Subject: WPPSS NUCLEAR PROJECT NO. 2
NRR APPROVAL OF WNP-2
SACRIFICIAL SHIELD WALL
WELD PREPARATION

WPPSS NUCLEAR PROJECT NO. 2
SACRIFICIAL SHIELD WALL
WELD PREPARATION

Subject: WPPSS NUCLEAR PROJECT NO. 2
 DOCKET NUMBER 50-397
 SACRIFICIAL SHIELD WALL (SSW)
CORRECTIVE ACTION PLAN

SUBJECT W. O. 2808
Washington Public Power Supply System.
WPPSS Nuclear Project No. 2
Sacrificial Shield Wall - Assessment Program
Connection of Upper and Lower Wall Segments
TECHNICAL MEMORANDUM NO. 1173

FIGURE 1

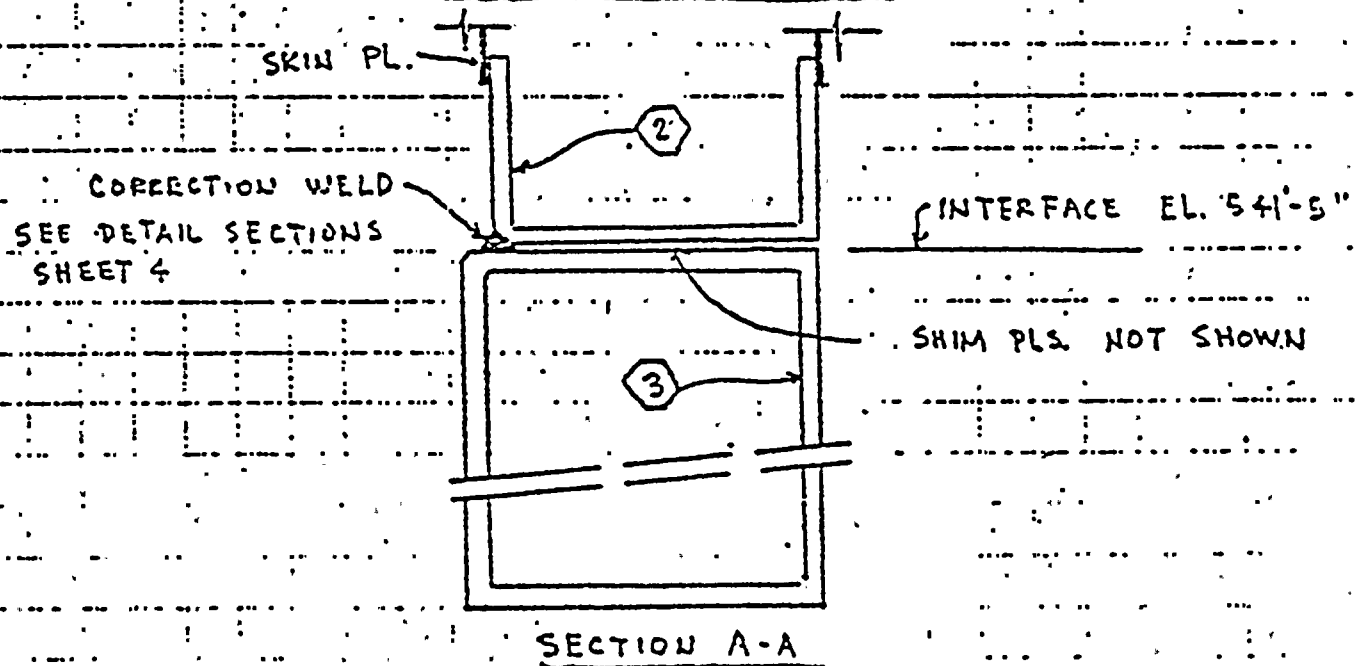
The correction weld is a partial penetration groove weld with fillet weld reinforcement to be installed along the exterior circumference between the rings above and below the interface at Elevation 541'-5". The location and extent of the weld are shown in Figure 1; weld details are shown in Figure 2.

As shown in the figures, the correction weld is to be installed in each of the 24 panels around the SSW for the width available between the column splice plates. Preparation for the groove weld requires removal of material from the channel ring. The specific configuration of the weld in each panel, including the groove depth and the size of the fillet weld reinforcement, depends on the width of ledge at the interface. From the design viewpoint, a minimum overall weld depth of 2 inches, corresponding to an effective weld throat of $1 \frac{7}{8}$ inches, is maintained in all configurations.

FIGURE 2

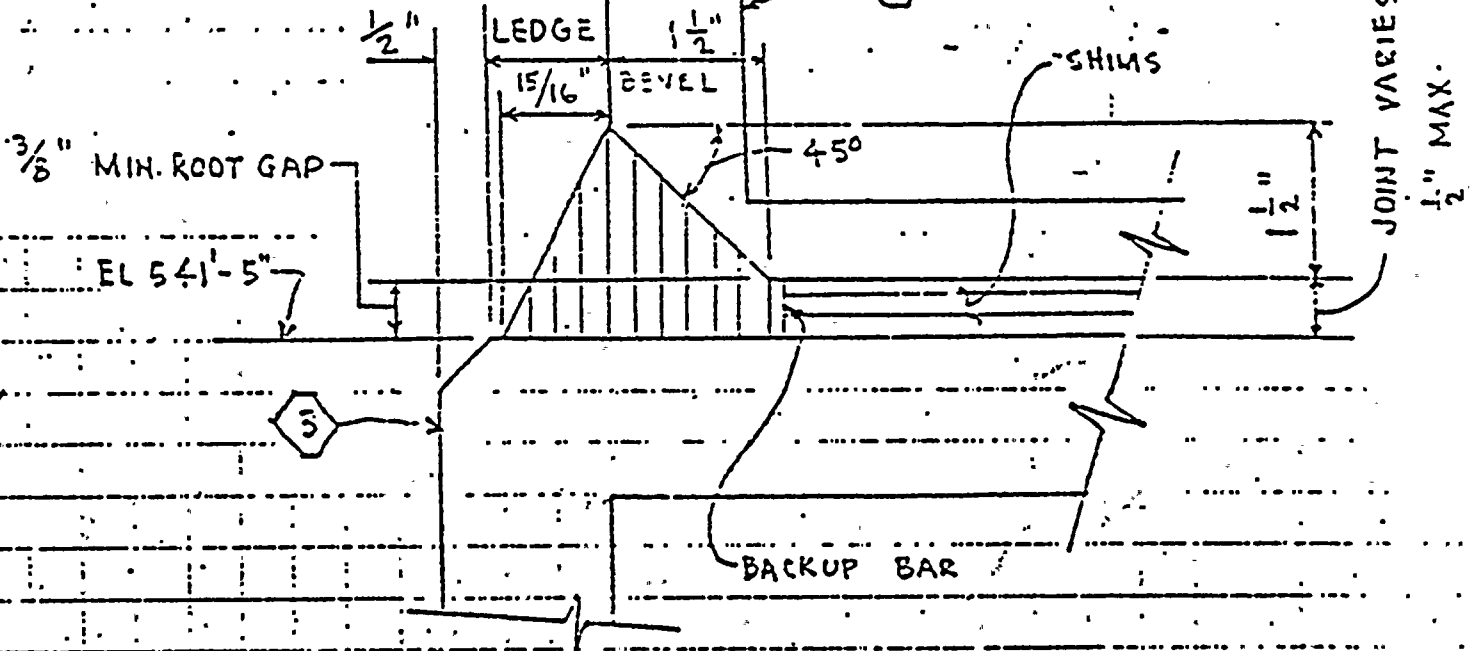
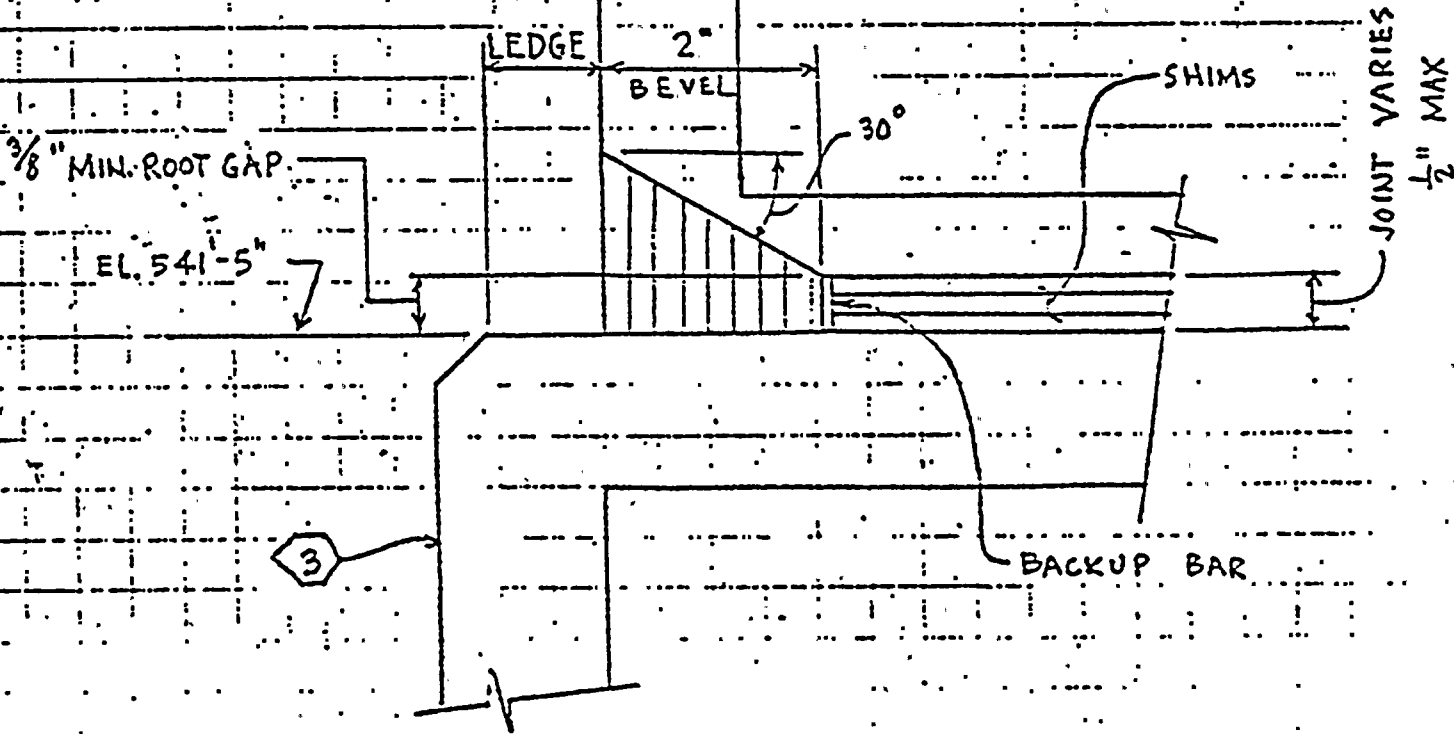
SECTION WHERE LEDGE IS A MINIMUM OF 1" WIDE

SECTION WHERE LEDGE IS LESS THAN 1" WIDE
REINFORCING FILLET TO BE ADDED AS
SHOWN ON SHEET 5 OF PED-215-CS-2741.

FIGURE 3

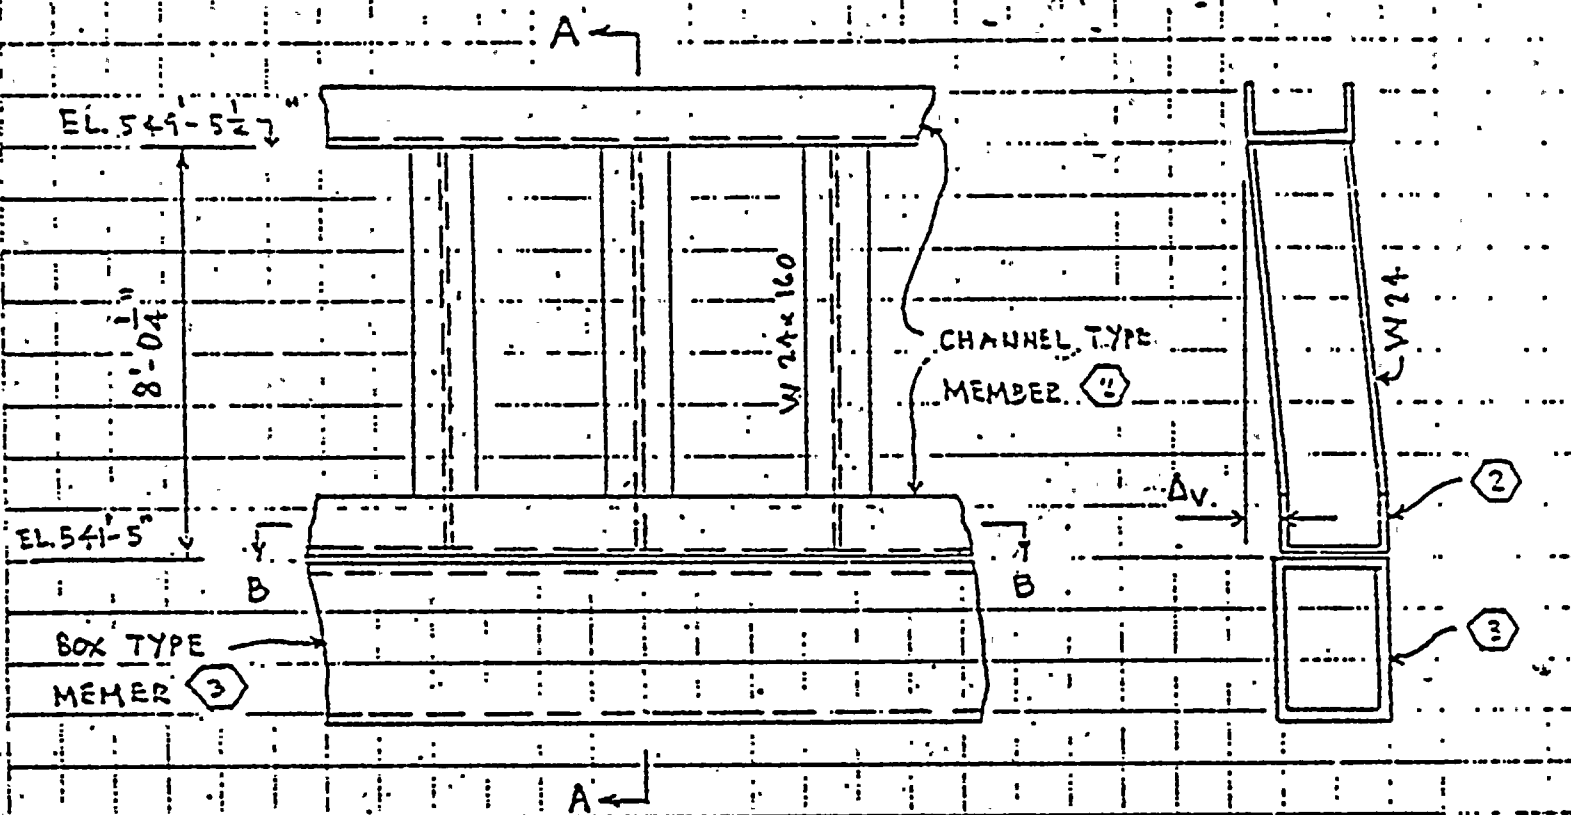
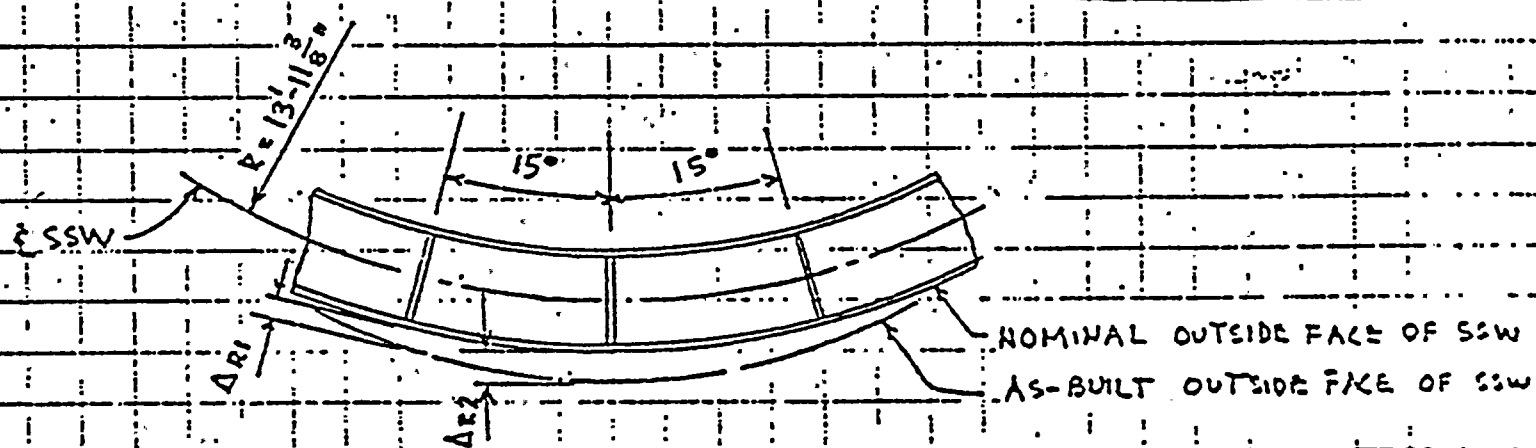
As-built deviations of the SSW which affect the proposed correction weld at interface Elevation 541'-5" are illustrated in Figure 3. As shown in the figure, the deviations from verticality of the columns above the interface and the deviations from the design circularity of the ring channel members above the interface are involved.

- b. Verticality - The maximum tolerance is taken to occur at a column between Elevation 541'-5" and Elevation 549'-5½". Using the terminology of Figure 3,

Field measurements pertinent to the vertical and circular deviations have recently been made. The magnitudes of Δ_v as defined in Figure 3 were determined around the shield wall. However, precise determination of the circular deviation is not practical due to interference of existing construction. As a measure of the circular deviation, the radial deviation between the ring box member below the interface and the ring channel above the interface is used.

Comparison of the deviations from field measurements with those based on the tolerances makes apparent the conservative basis of the analysis. Thus the analysis uses $\Delta_v = 1.8$ inches compared to a maximum measured value of 0.625 inches. Also, the analysis uses $\Delta_{Ci} - \Delta_{Ci+1} = 1.8$ inches compared to a corresponding value of 0.875 inches based on field data.

SECTION 6384-6384
TYPICAL WELD PROFILE WHERE LEDGE
IS A MINIMUM OF 1" WIDE.

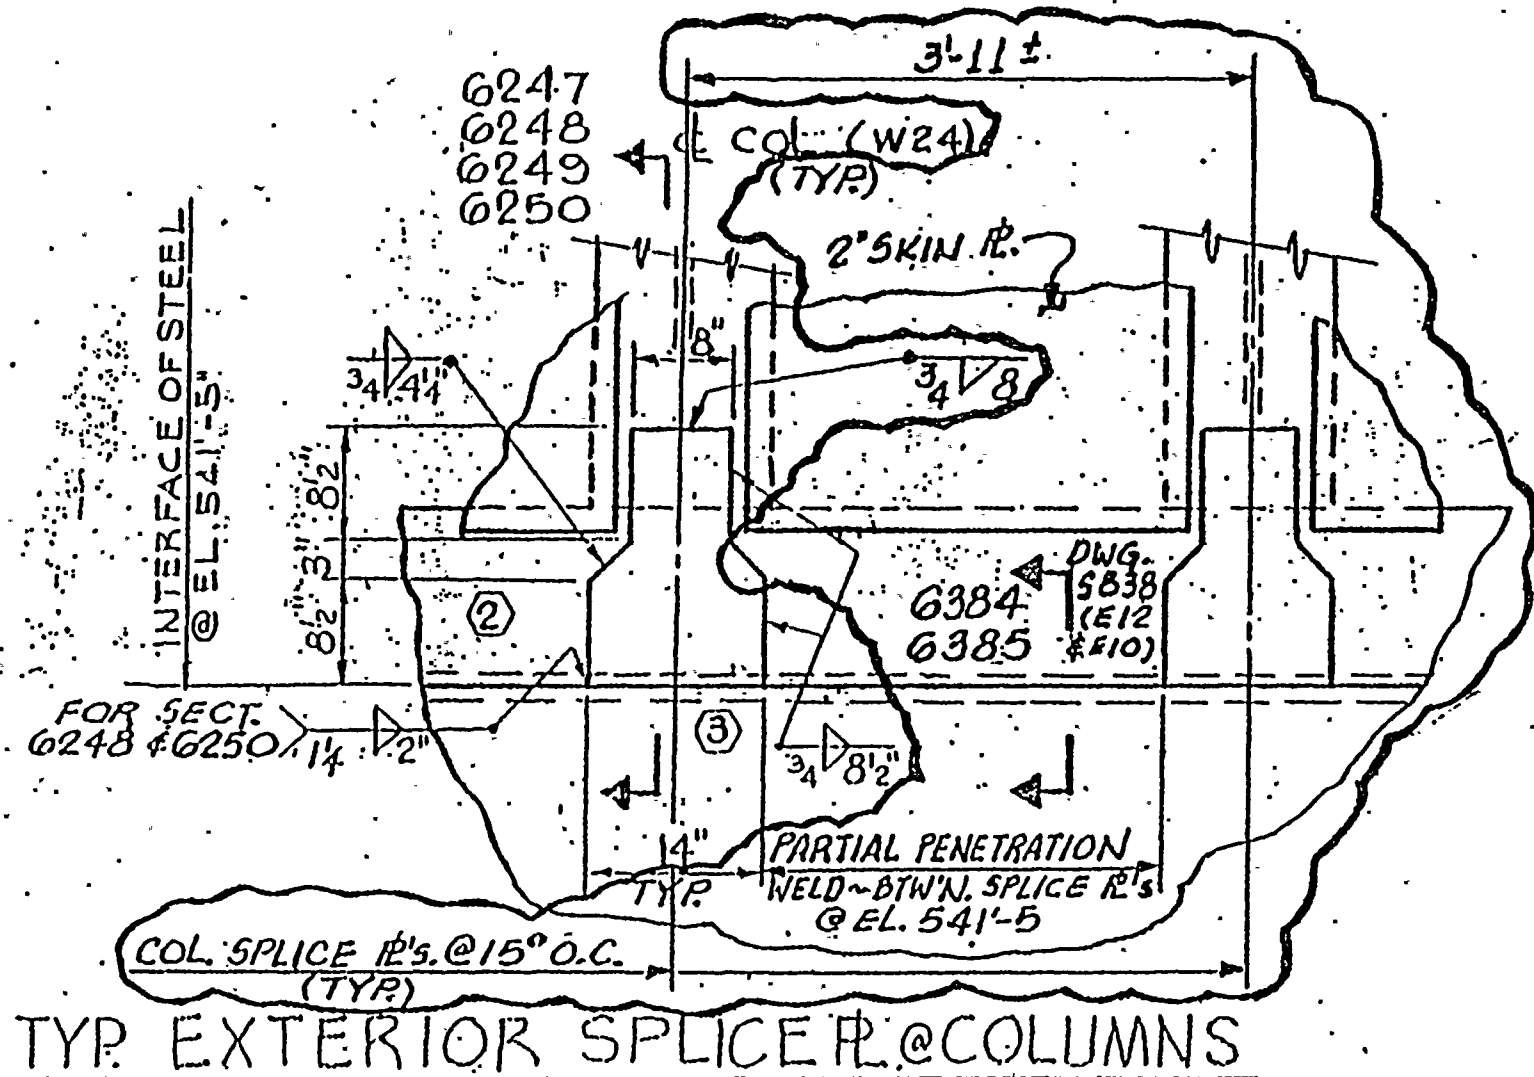
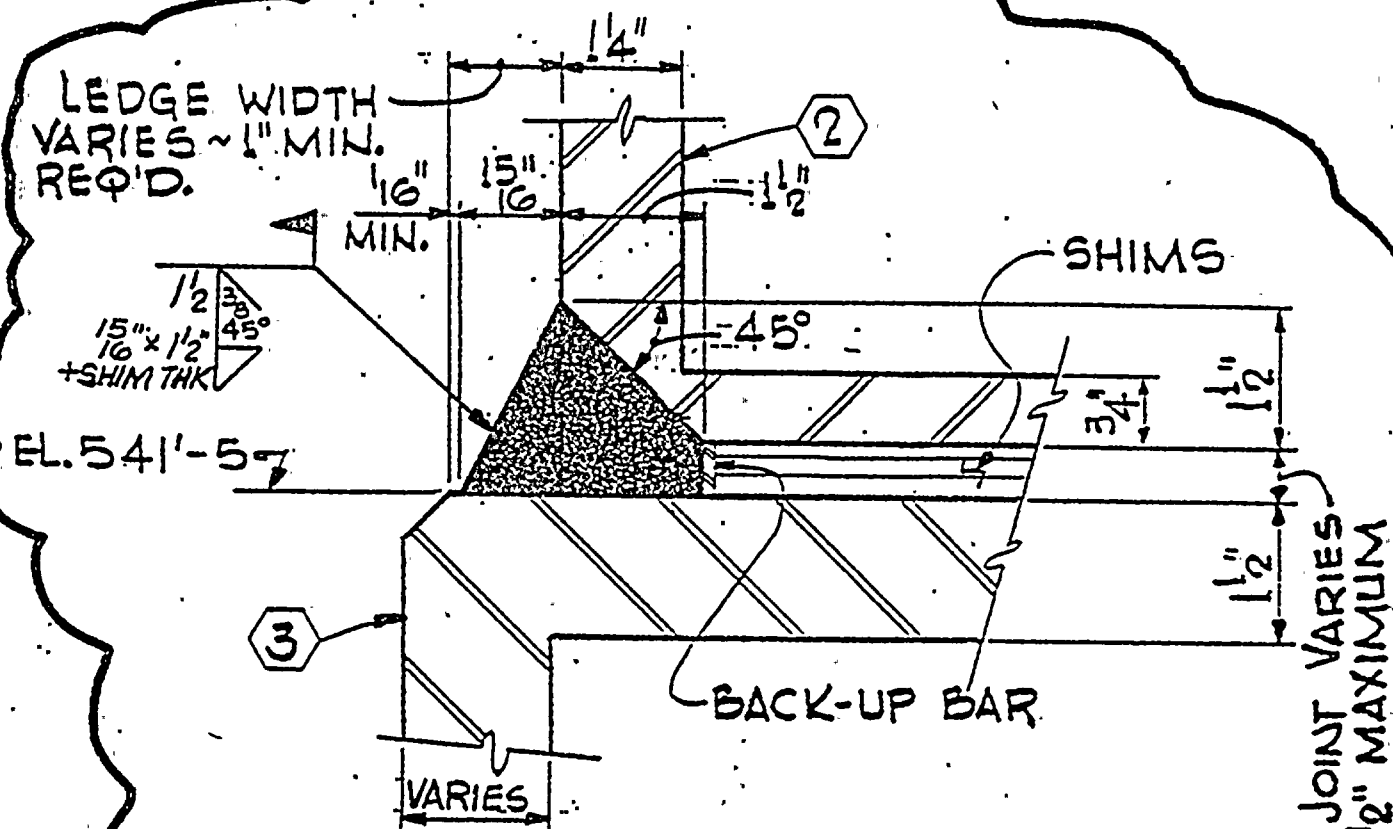
SLOT WELDS REQUIRED PER
DETAIL D-2038 (S782) MADE
TO TOP OF SHIMS AND DO NOT
CONNECT RING 3 (BEAM TYPE ③)
AND RING 4 (BEAM TYPE ②) AS
REQUIRED.

REPLACE SLOT WELDS WITH A PARTIAL
PENETRATION WELD BETWEEN THE UPPER AND
LOWER RINGS AS DETAILED ON SHEETS 3
THRU 5 OF THIS P.E.D.
